**Errata Sheet for the Ashland/Northern States Power Lakefront Superfund Site
Final Remedial Investigation Report Dated August 31, 2007**

RI REPORT

ERATA SHEET FIGURES

PROJECT: ASHLAND/NSP LAKEFRONT SITE ASHLAND, WISCONSIN			
TITLE: FIGURE 1-3 FORMER MGP FEATURES			
DRAWN BY: DDZ		SCALE: 1" = 60'	PROJECT: 25688375
CHECKED BY: PJS		DATE: 30.JULY.2007	SHEET: 1-3
APPROVED BY: DPT			
URS		10200 INNOVATION DRIVE, SUITE 500 MILWAUKEE, WISCONSIN 53226 414-831-4100

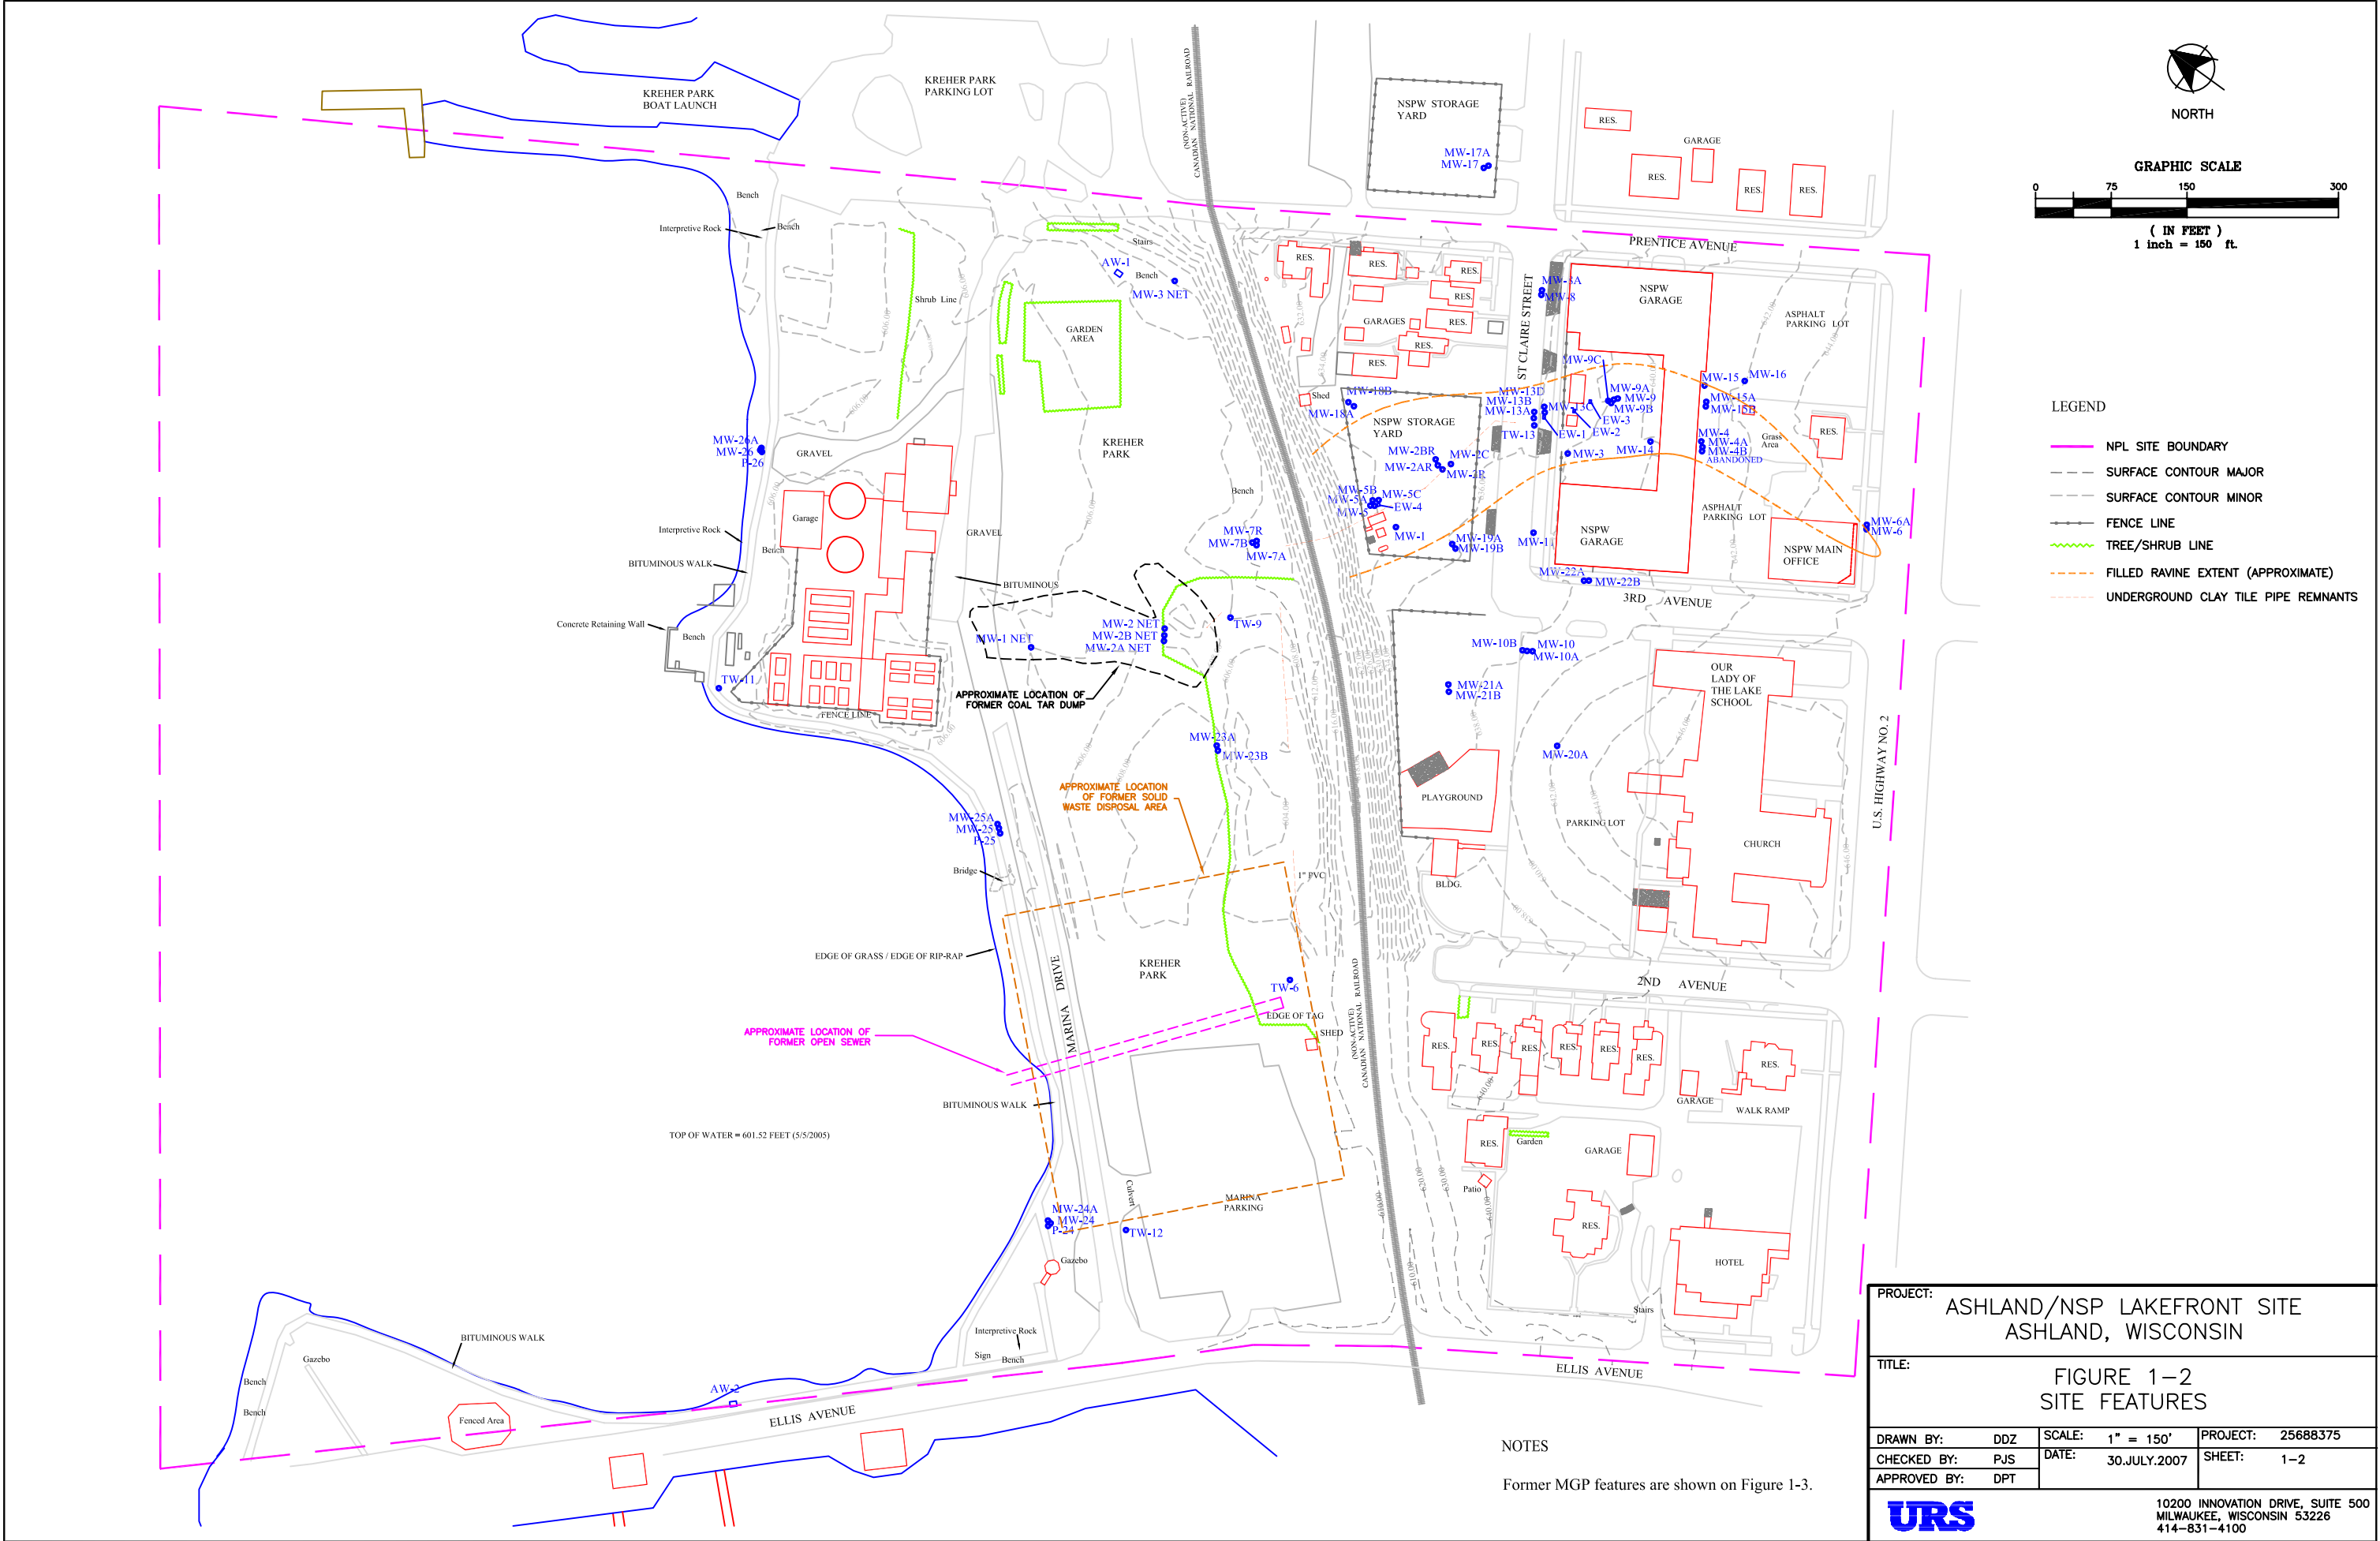
3. *Figure 1-3 – This figure should include the clay tile pipe trace.*

The clay tile pipe trace has been added to Figure 1-3

TITLE: Figure 5-2
Soil & Sediment Isoconcentration Total VOCs
Upland Soils and Bay Sediments

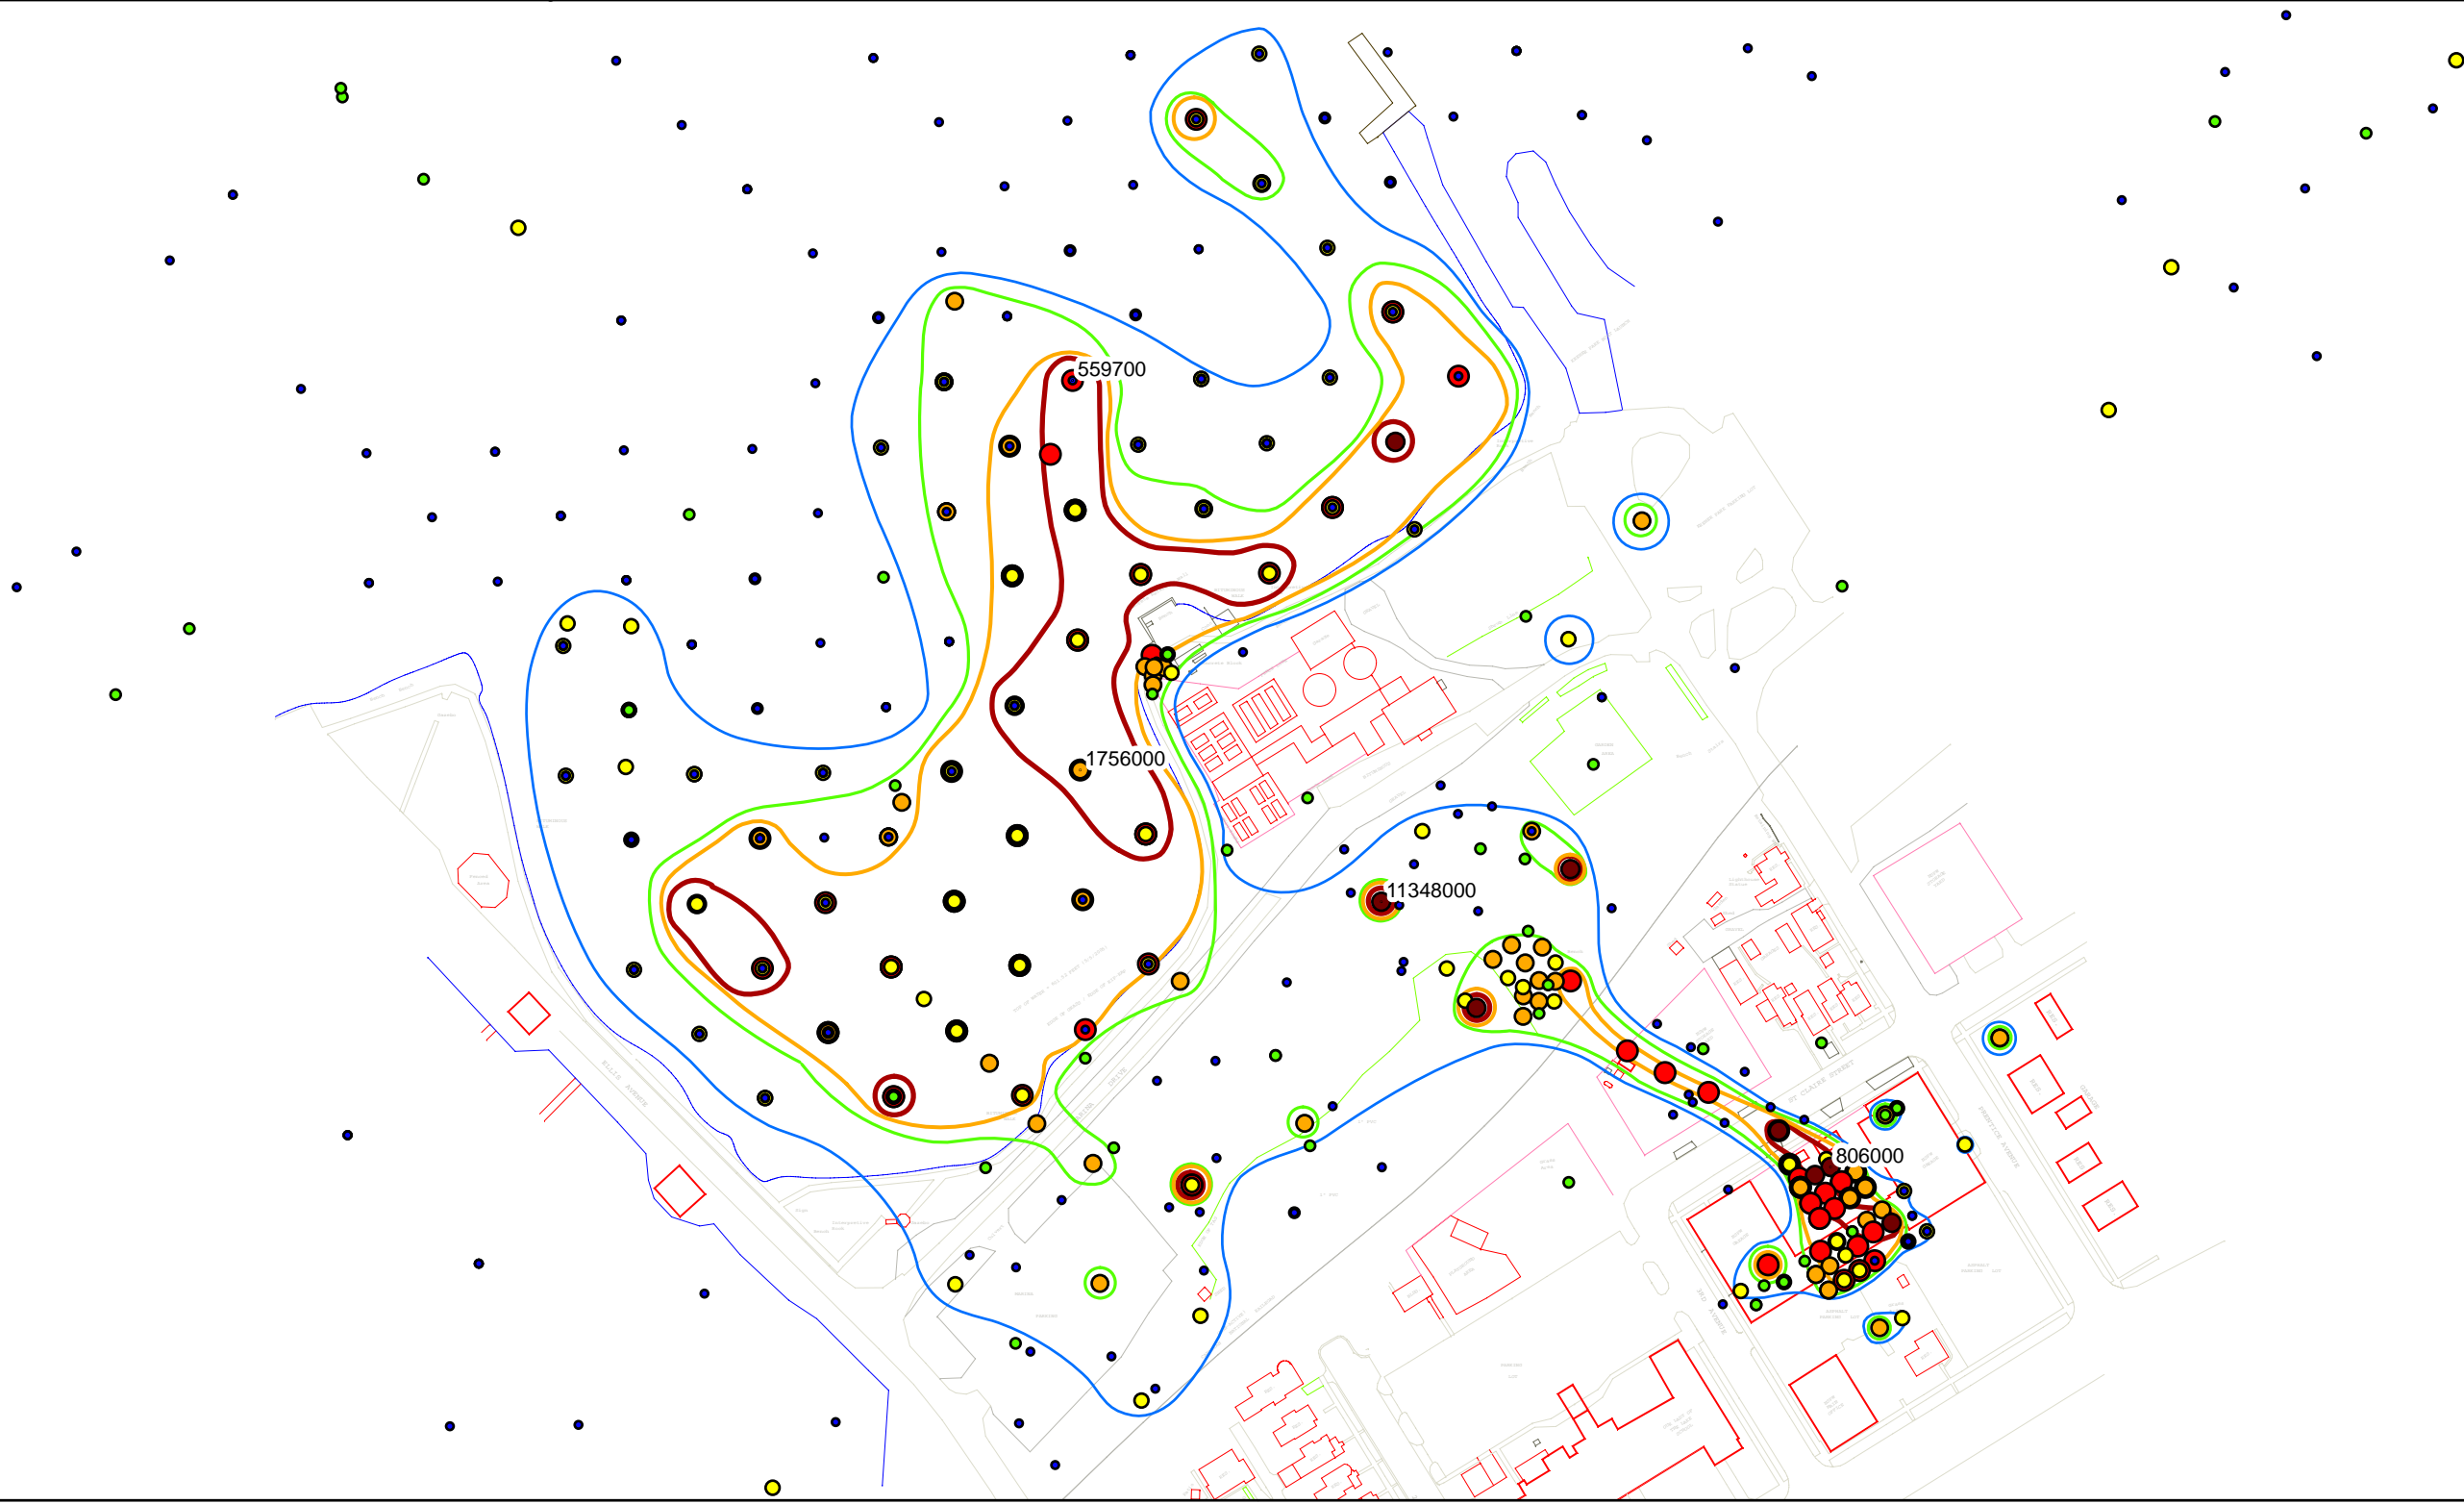
4. *Figure 5-2 – The 100,000 ppb. There has been no “clean” area documented at St. Clarie Street or the RR tracks.*

Figure 5-2 has been modified by enclosing the 100,000 ppb contour to include the filled ravine at the upper bluff area and the coal tar dump area at Kreher Park.

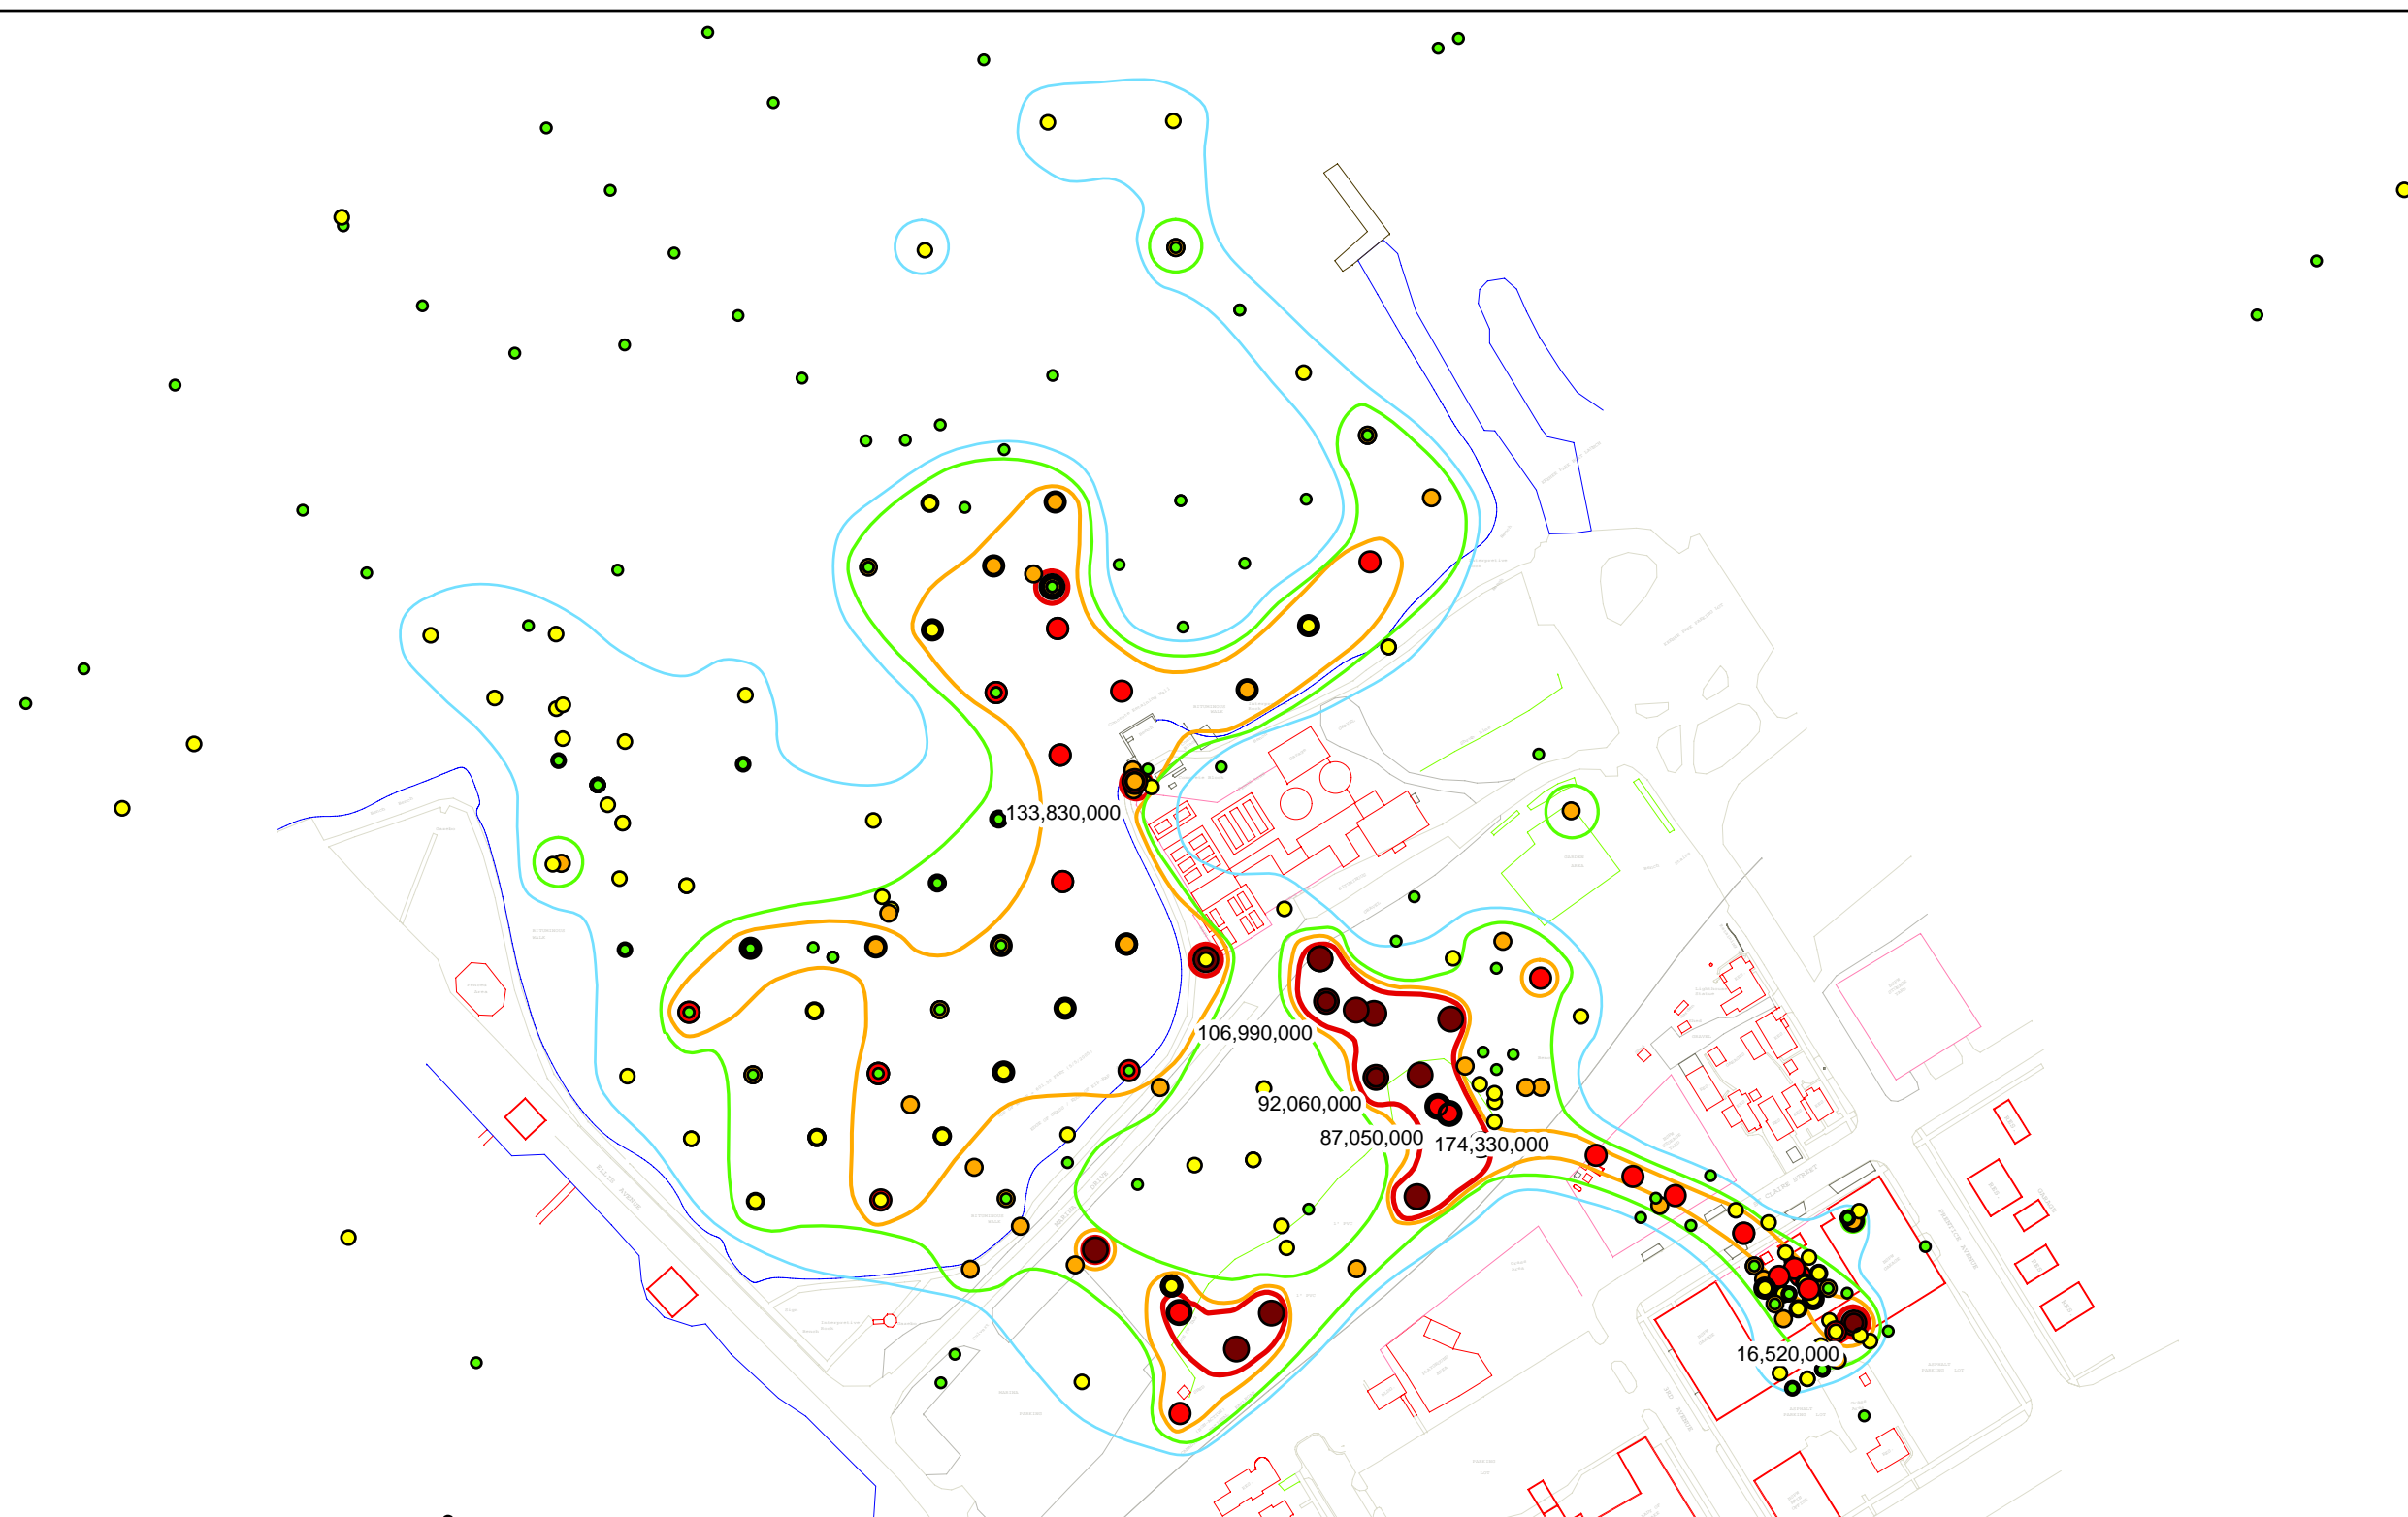
6. *Figure 5-5 – The 1,000,000 ppb isoconcentration lines should be connected from the “court yard” through to the seep/coal tar dump area.*

Figure 5-5 has been modified by enclosing the filled ravine in the upper bluff area and the coal tar dump area in Kreher Park within the 1,000,000 ppb contour. The total PAH concentration at GP-122 at the upper bluff area has also been labeled. The footnote explaining the highest total PAH concentrations at Kreher Park has also been modified to reference the GP-122 data.
